APPLICATION FOR APPROVAL OF DETAILS RESERVED BY CONDITION

Planning Permission: 10/00213/FUL
Listed Building Consent: 10/00214/LBC
Proposal: Conversion and Extensions of Buildings to Form 3 Dwellings
Location: The Pool House, Newtown Linford Lane, Groby
Applicant: Mr James Everson Crane

DETAIL DRW. Nº DD/PHL/01.

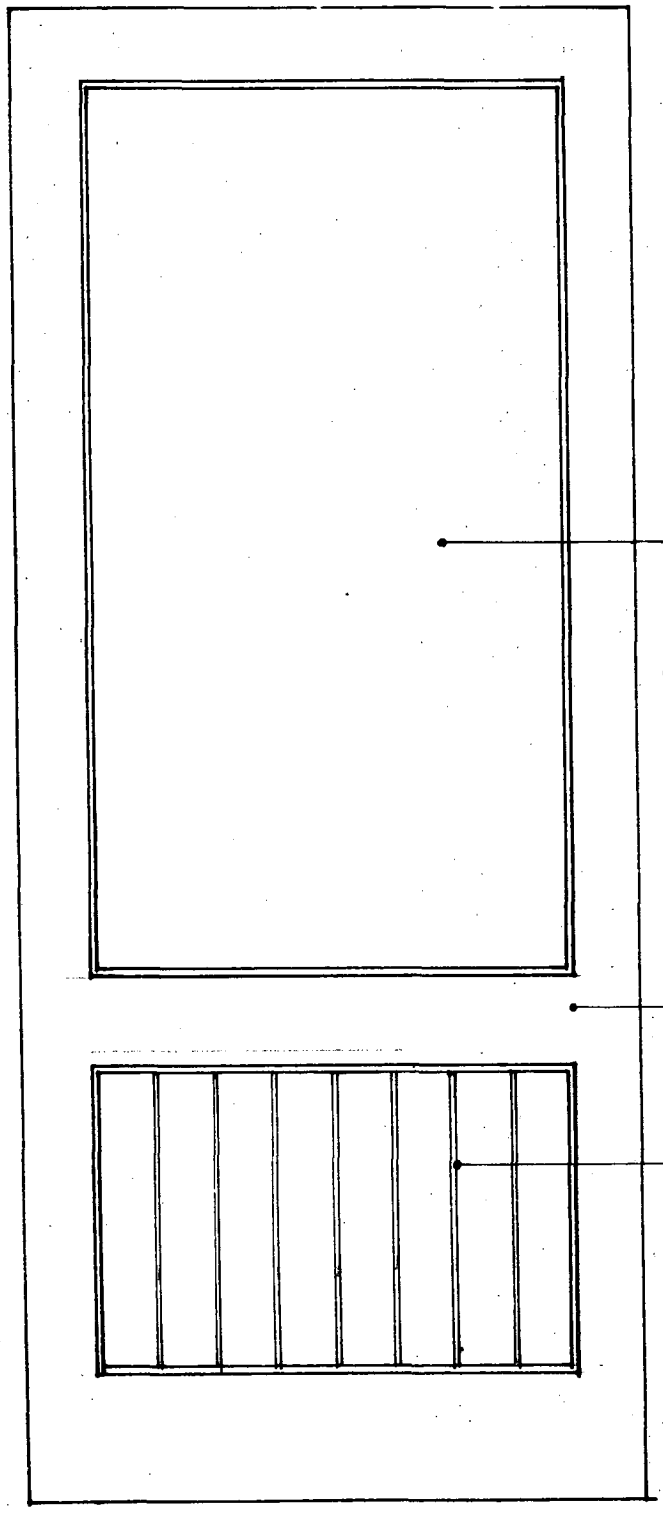
1.2 *Condition No. 5: Details of Rainwater Goods, Windows, Roof Light and Doors*
After the discussions on site, it is confirmed that the windows within Pool House Lodge and extension will use Slimlite double glazing units, as agreed. Attached are revised drawings for the door/window combinations [dwg nos. DD/PHL/01 & DD/PHL/02] clearly annotated to show the use of Slimlite double glazing units.
